April 22, 2024

**Re: *Conditional Use Permit Application Submittal – 0 Maplewood Avenue***  
Maplewood Avenue Drainage Improvements – North Mill Pond Outfall  
Portsmouth, NH

RE: Wetland Conditional Use Permit for property located at 0 Maplewood Avenue (LU-24-43)

**NORTH MILL POND AREA PLAN VIEW**

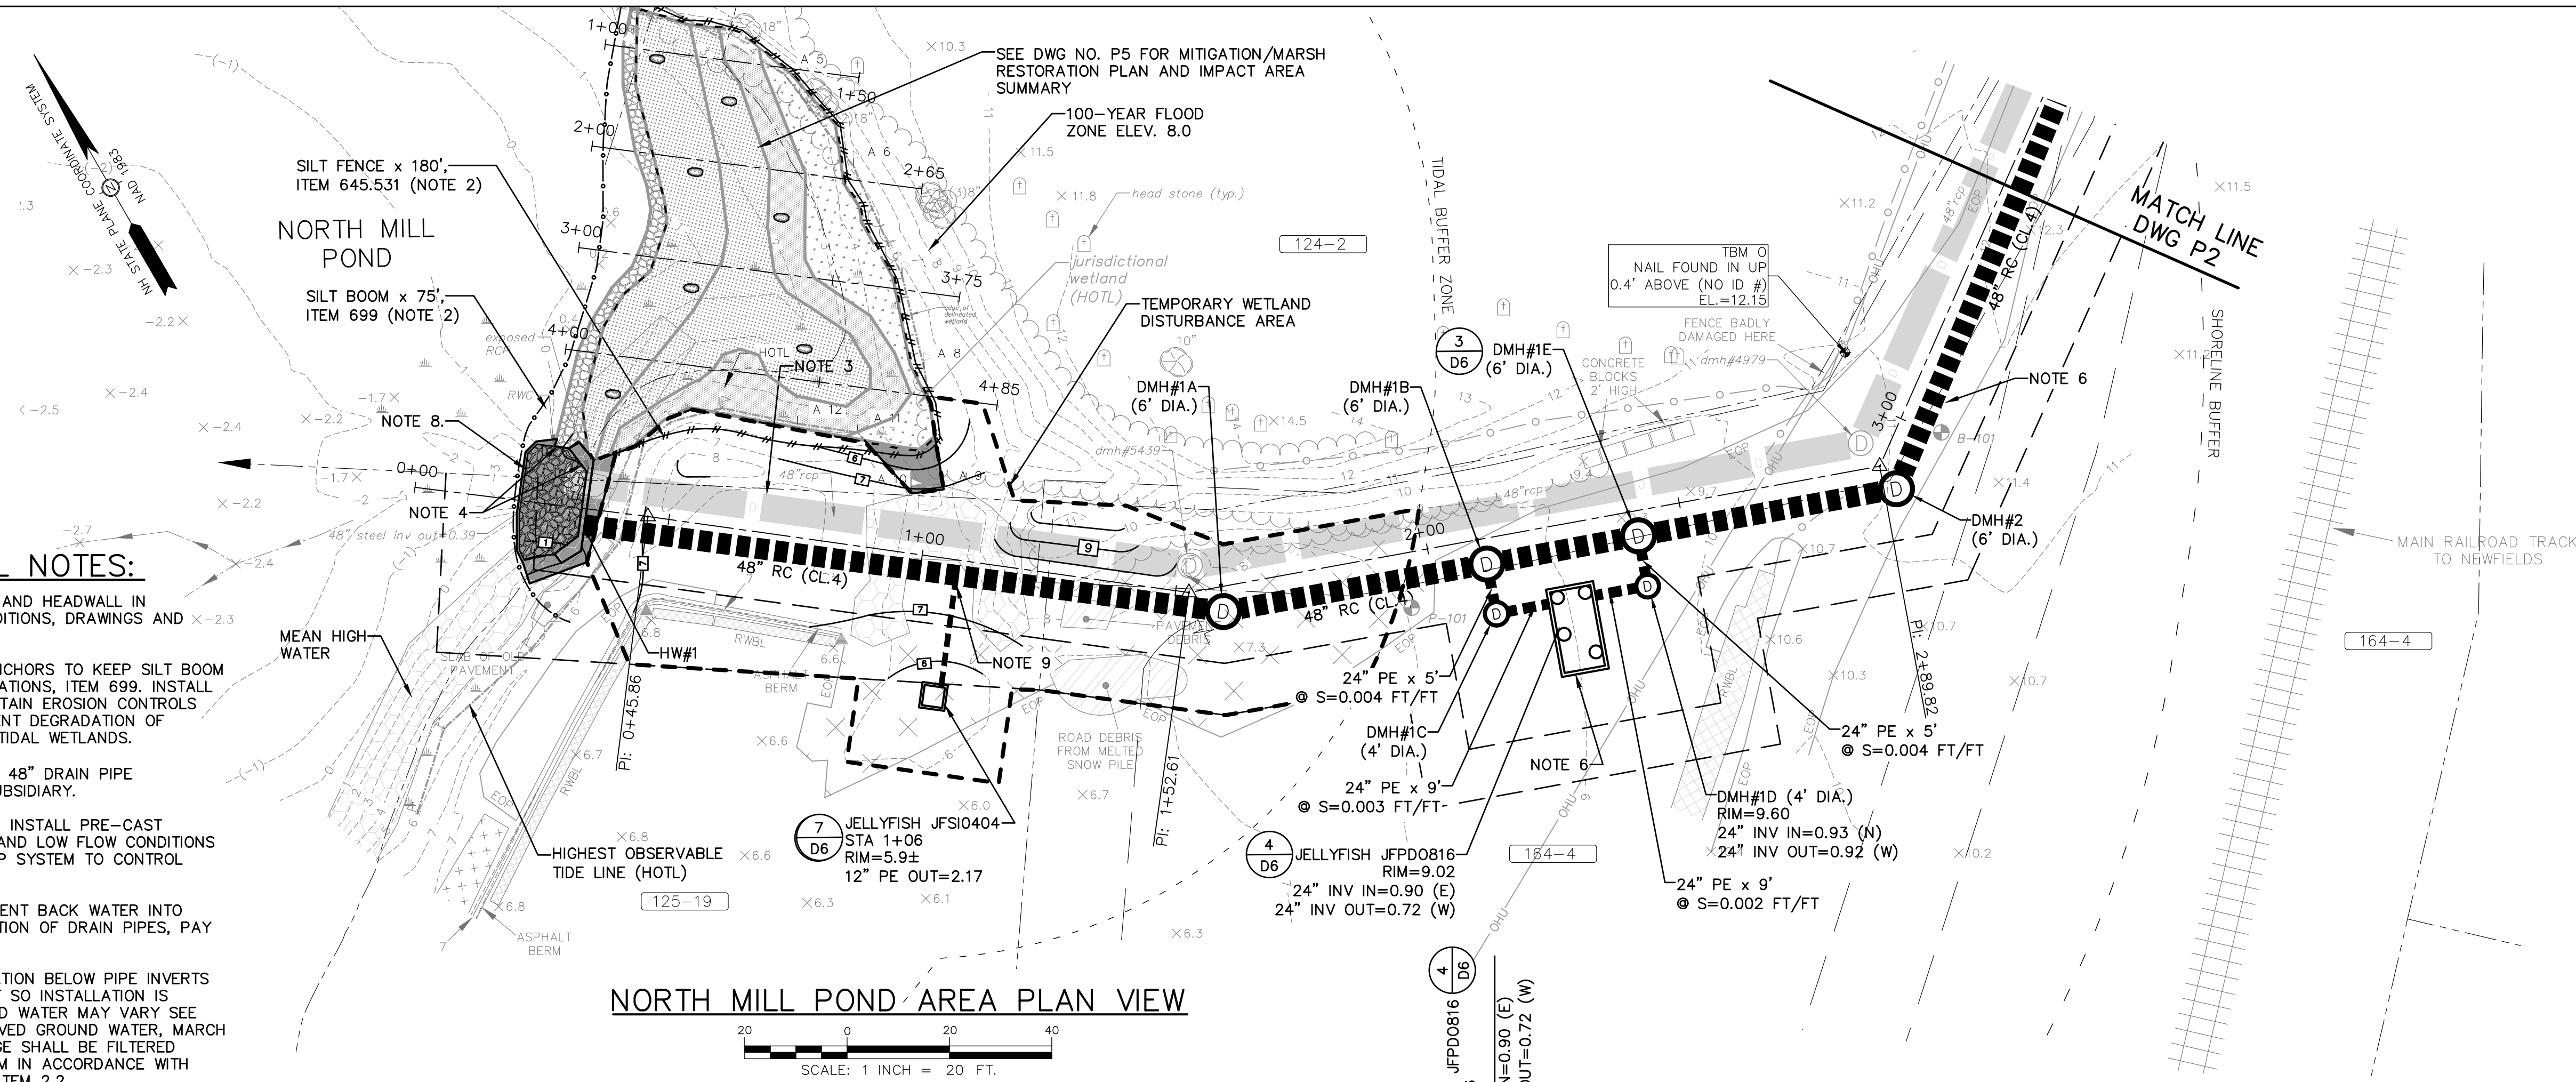
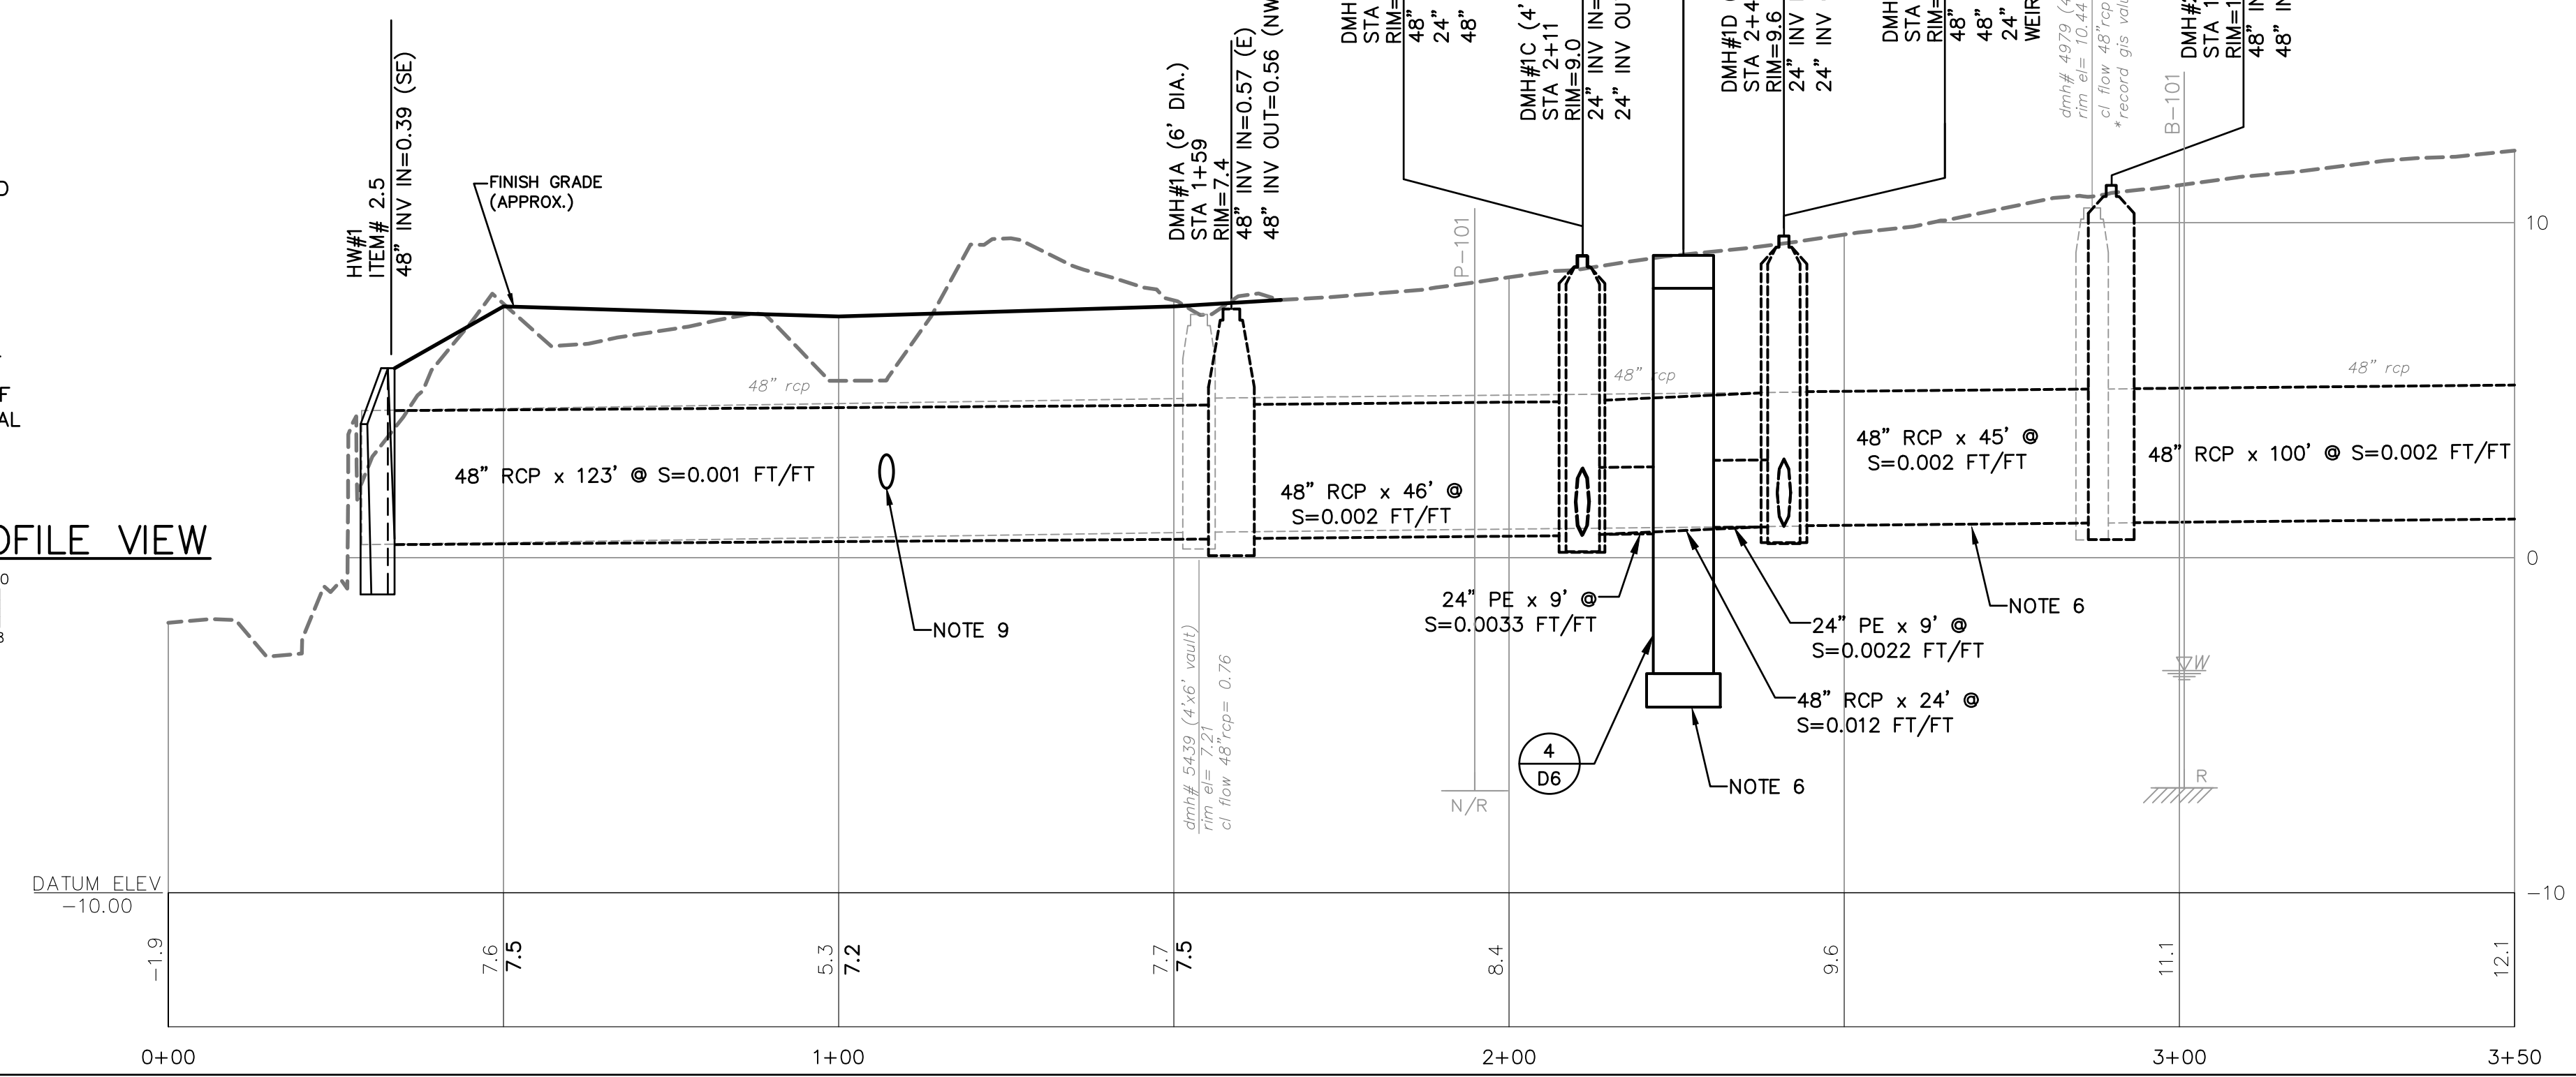
- A note shall be added to the plans stating all soil and plant material excavated on site shall be removed and disposed of off-site.

- A conservation seed mix or other appropriate native seed mix shall be used on impact areas disturbed within the wetlands buffer.

*Note #10 was added to sheet #5 (DWG P-1) regarding the presence of invasive species and removal of said species and soils shall be in accordance to NHDOT Best Management Practices for Roadside Invasive Plants*

*Note #11 was added to Sheet #5 (DWG P-1) specifying conservation seed mix be used to revegetate existing vegetated areas within the 100' tidal buffer.*
